To:	Spring Lake Park Planning & Zoning Commission City of Spring Lake Park	From:	Phil Carlson, Stantec
File:	Collision Doctor, Auto Repair 8370 Pierce Street NE Applicant: Charles Schatz, Reprise Design Owner: Olmedo Alvarado	Date:	November 23, 2020

**Re: Variance, Side Setback, 8370 Pierce Street NE**

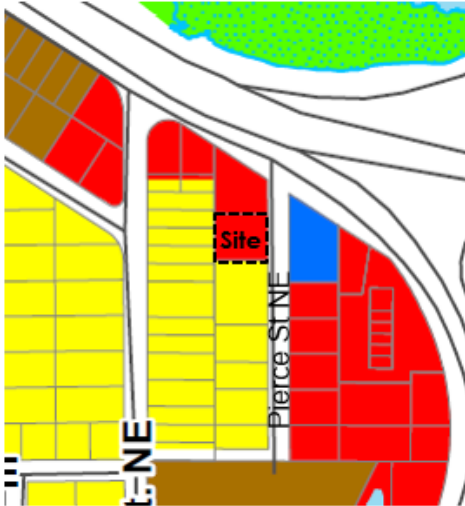
The business wants to expand by constructing an addition to the rear of the building in the northwest corner of the site. The proposed addition would line up with the existing building edge, which is 10 ft from the north lot line, whereas a 15-ft side setback is required by code. A variance is requested to construct the addition with a 5-ft variance to the side setback.
